# The Full Detector Design: considerations from the last MC campaign

*G.B., S.M.  
INFN Milano  
15 Mar 2023*

# Original design (motivated by historical considerations)

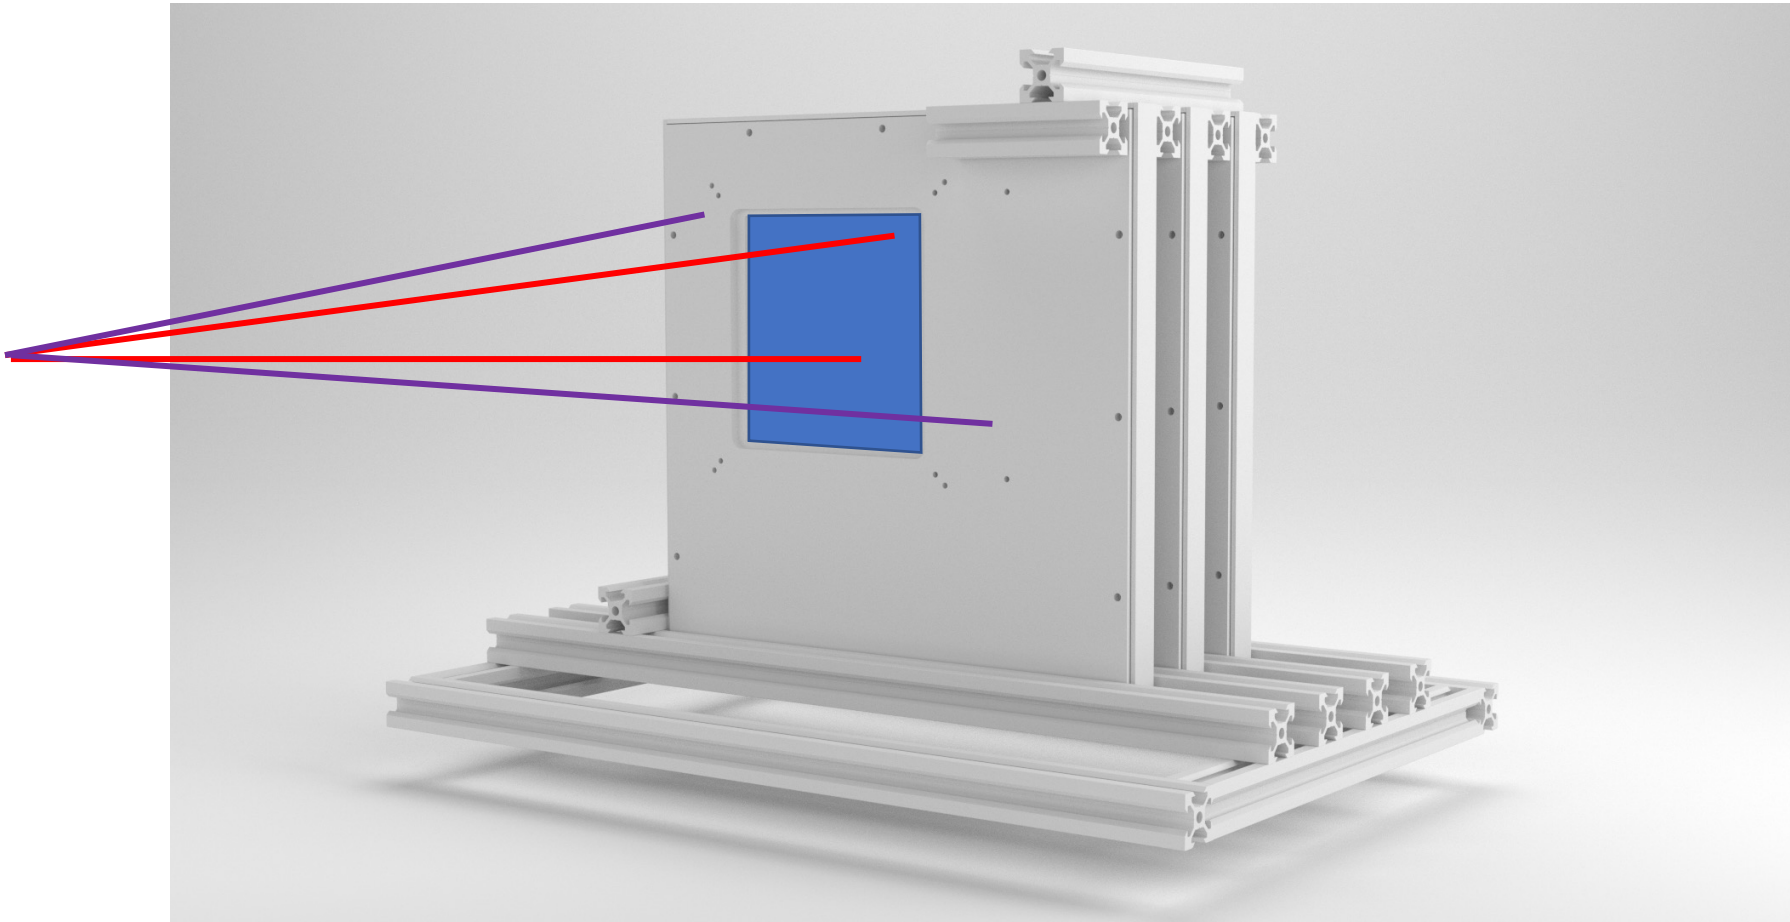
We have learned that the 100 cm distance, although maximizing the overall acceptance, is not optimal for our physics resolution. Furthermore, we might have mismatches between TW and MSD acceptance

It can be very important that all the tracks pointing to TW are those which cross the active area of MSD, to minimize problems of interactions in passive materials

# A possible solution

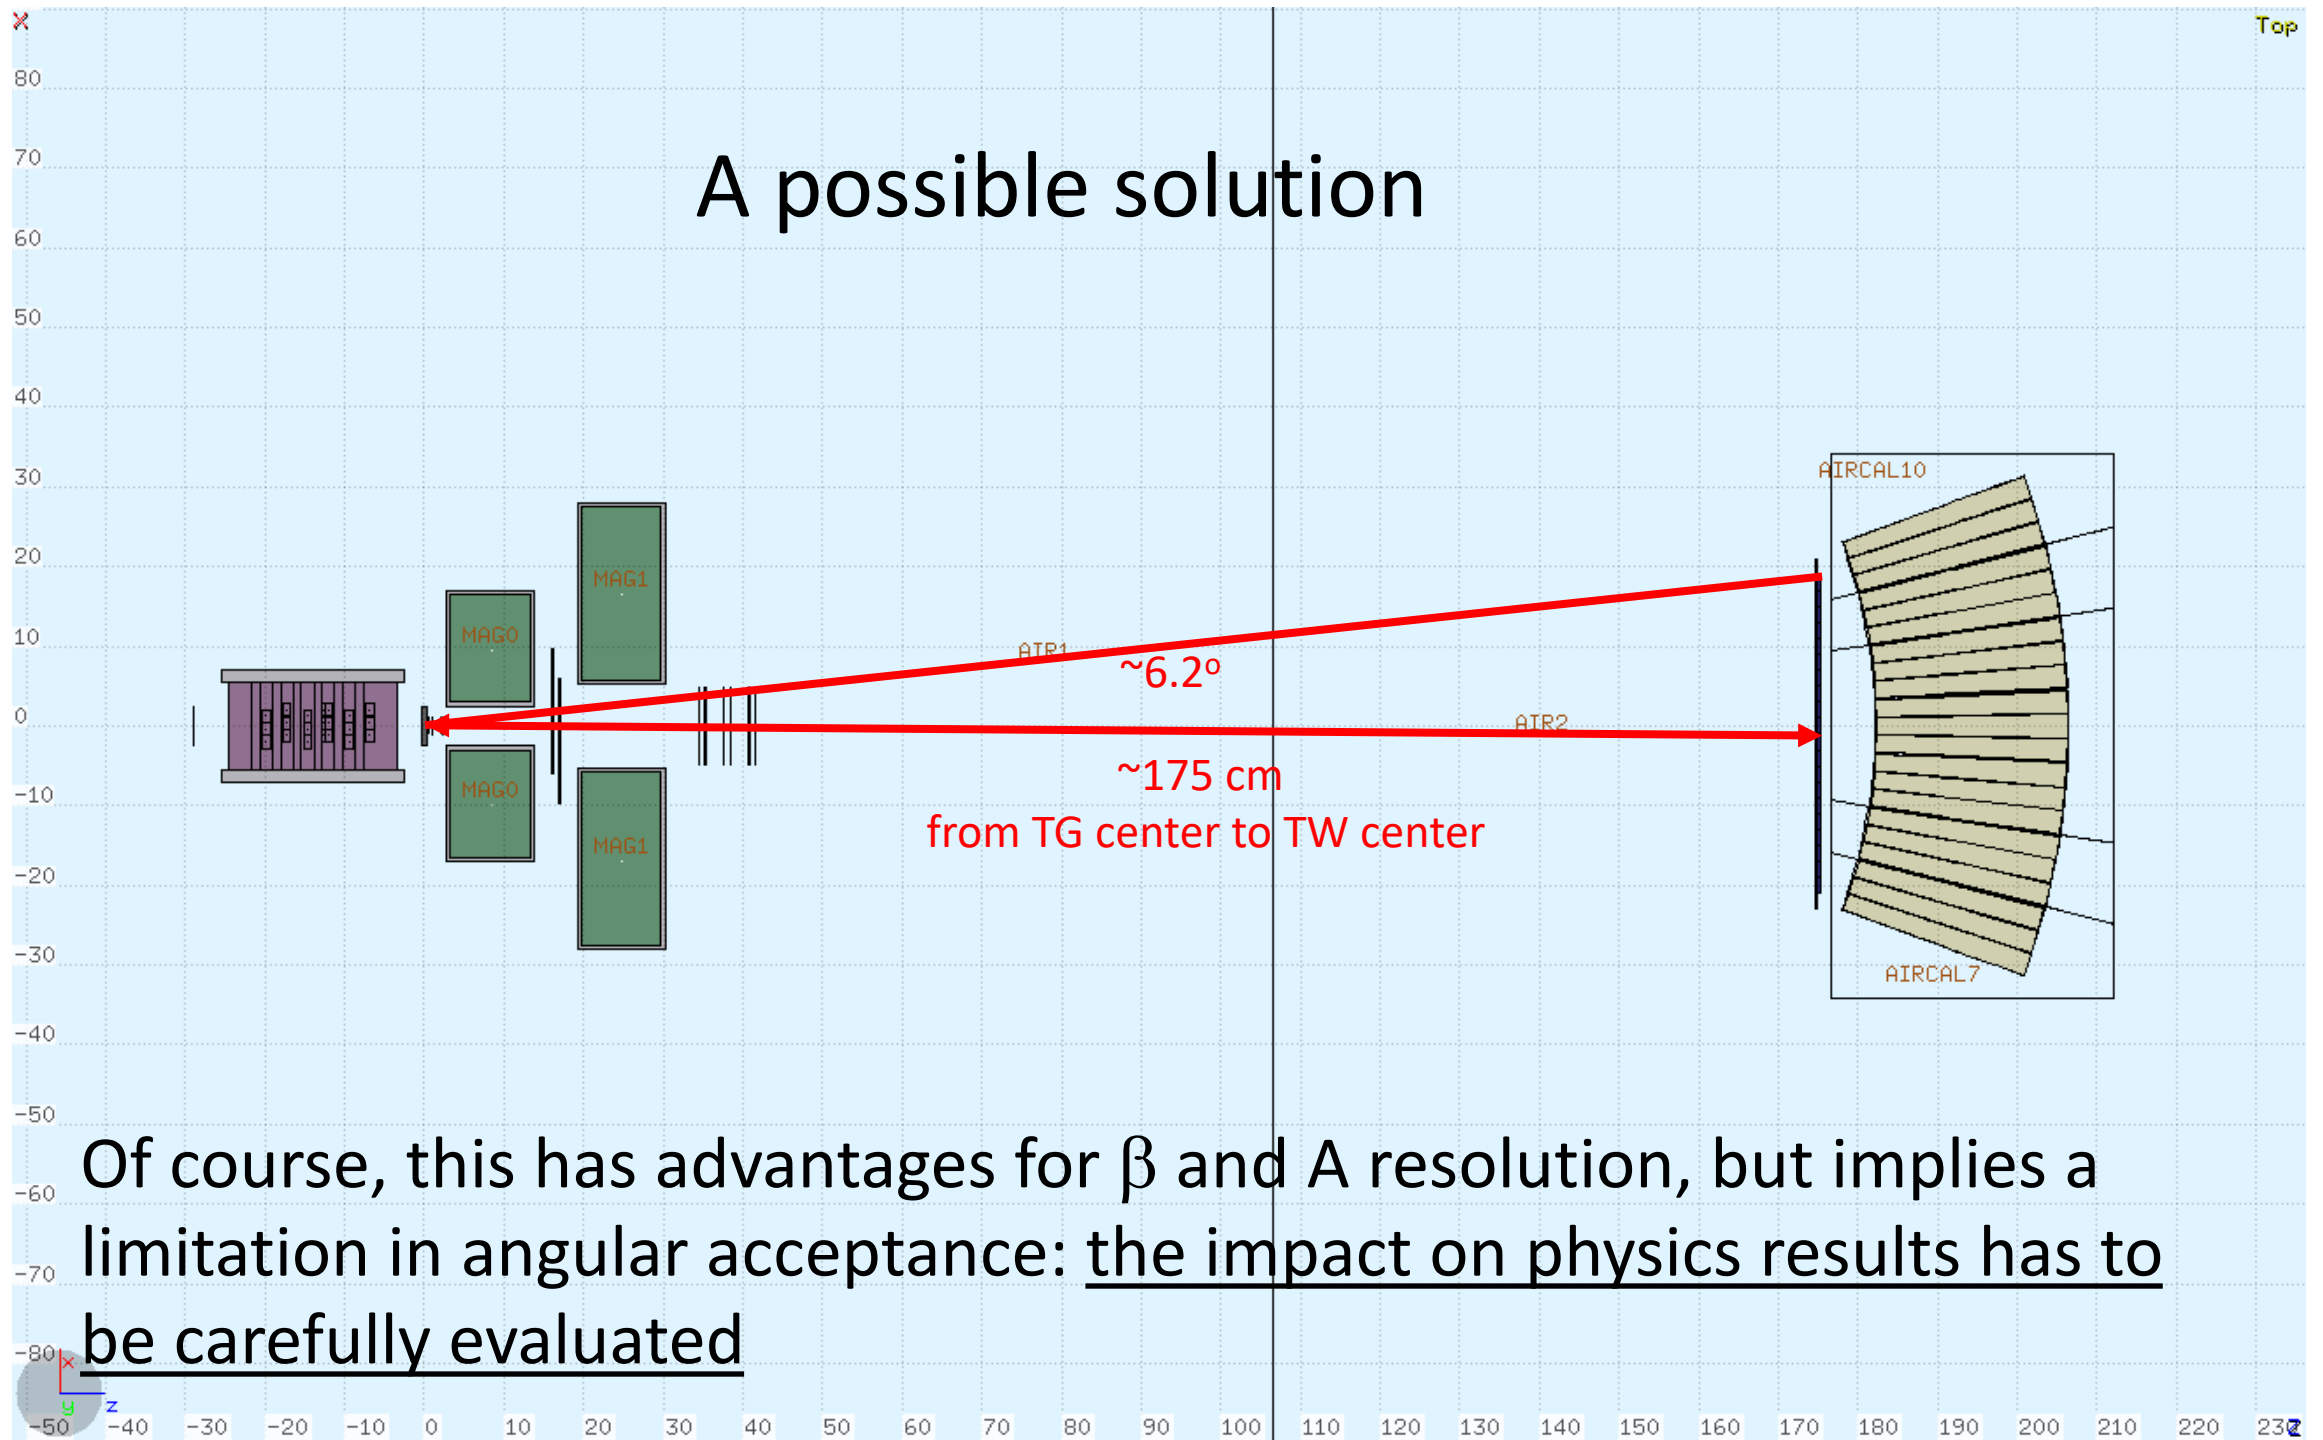
Of course, this has advantages for  $\beta$  and A resolution, but implies a limitation in angular acceptance: the impact on physics results has to be carefully evaluated

# The lateral shift due to magnetic field - 2

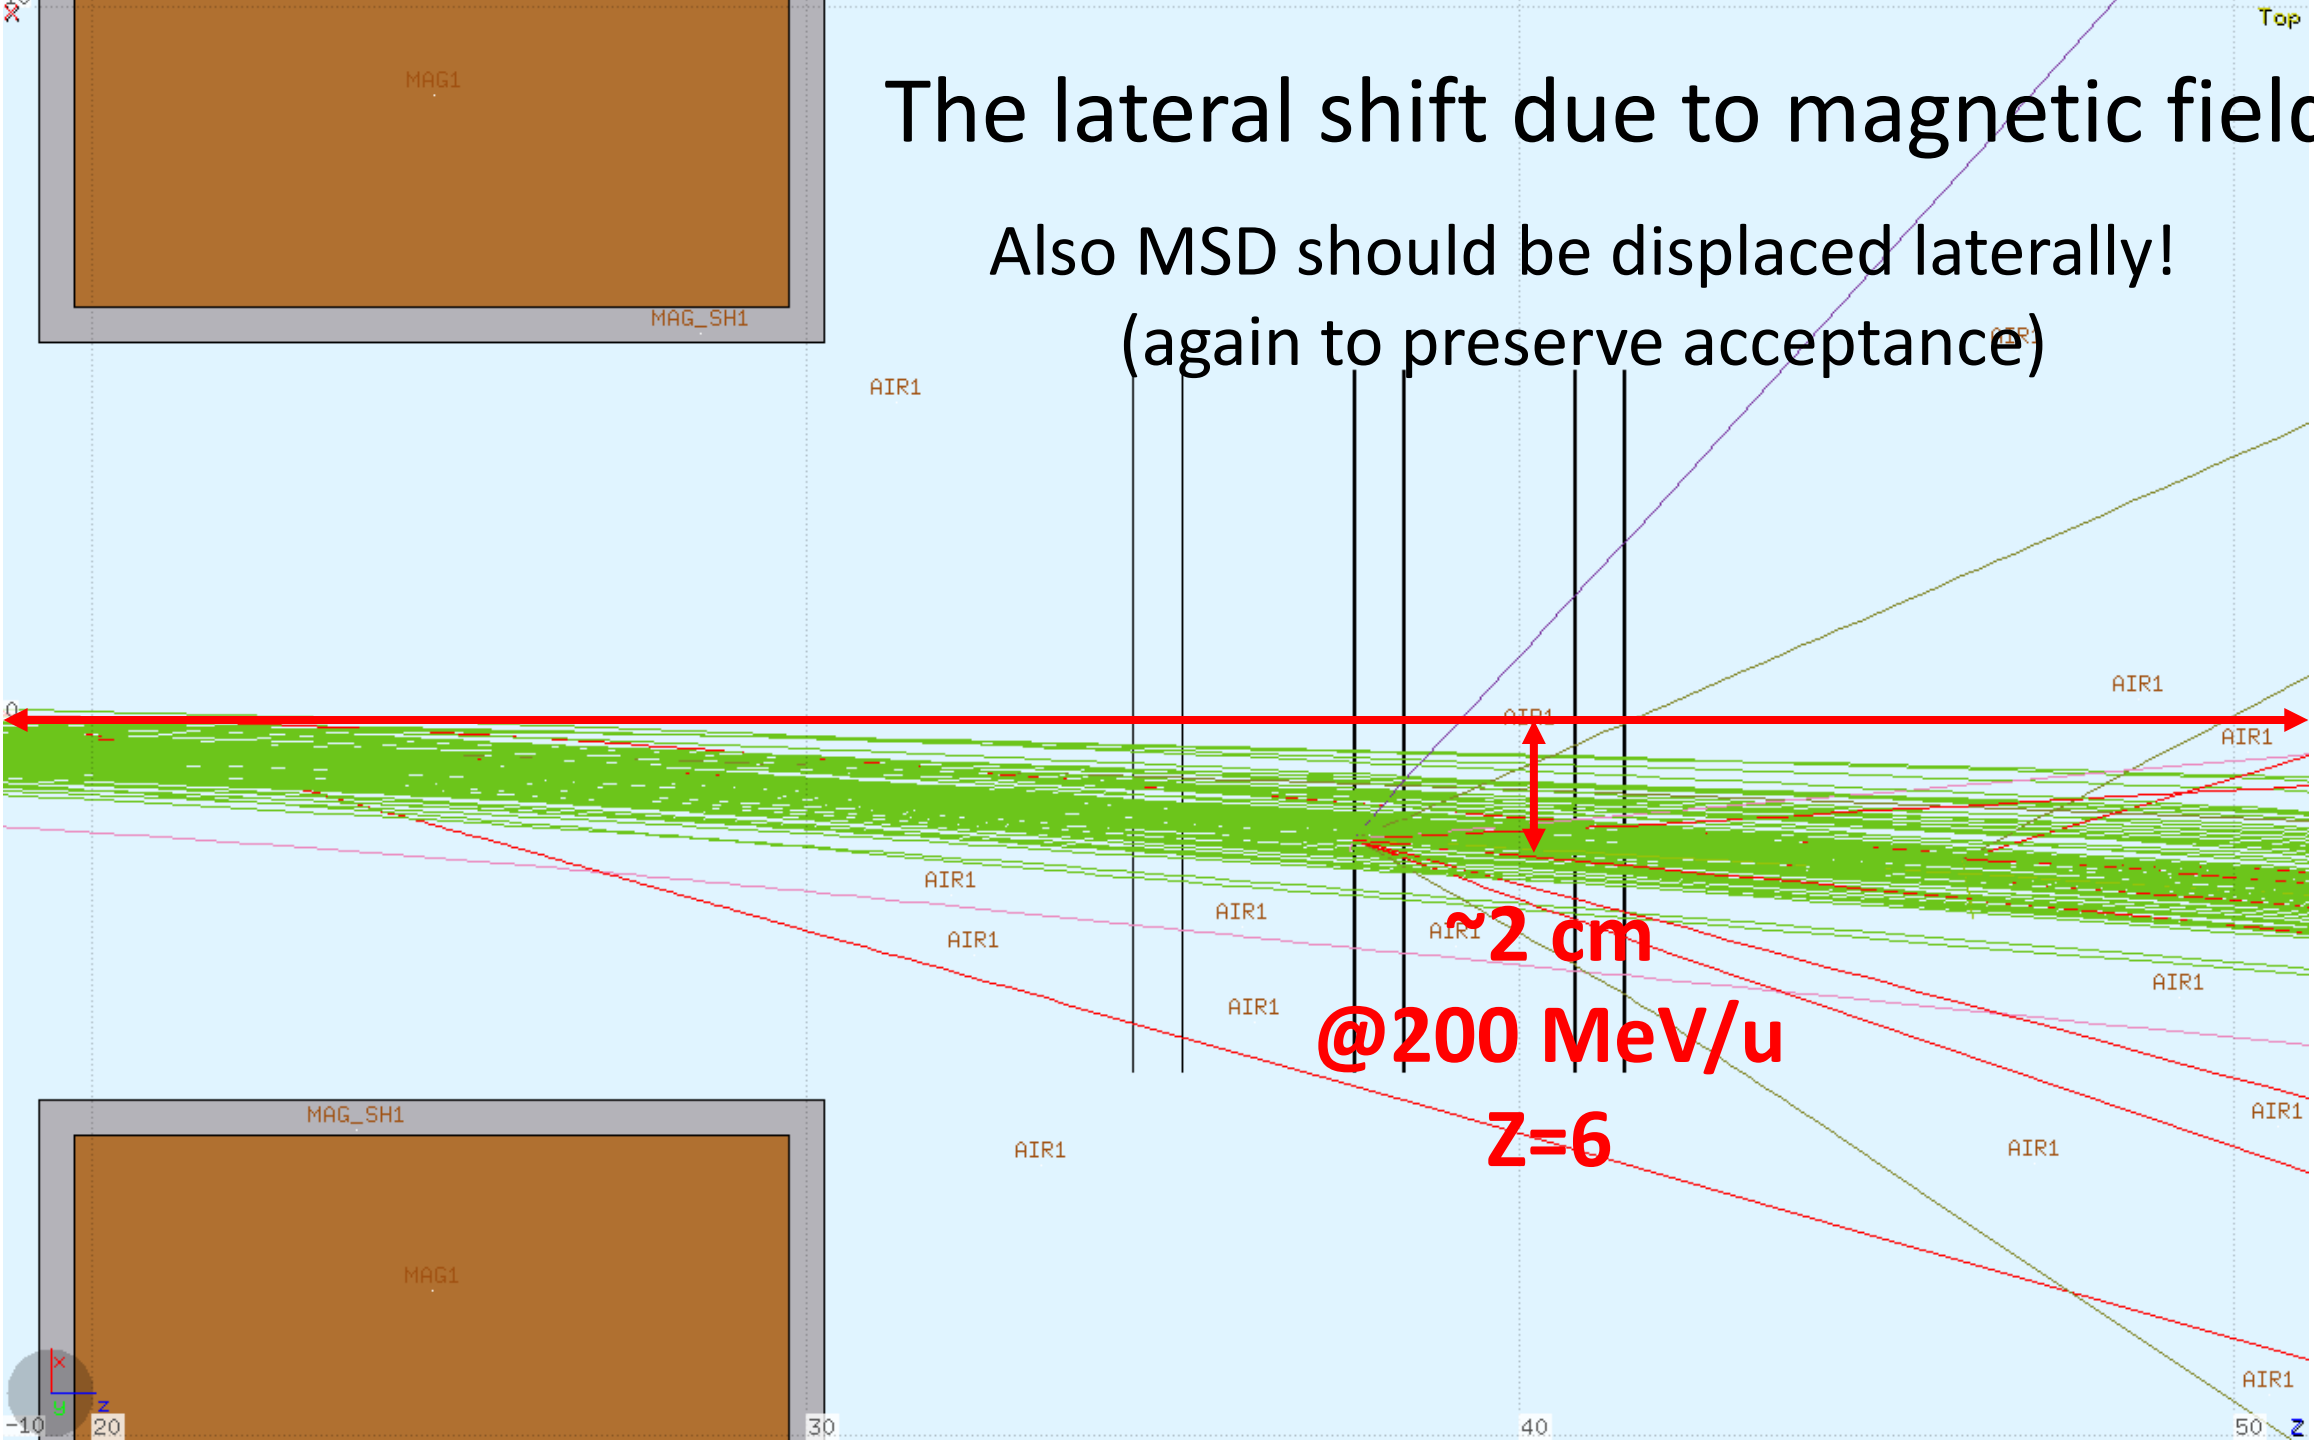
Also MSD should be displaced laterally!  
(again to preserve acceptance)
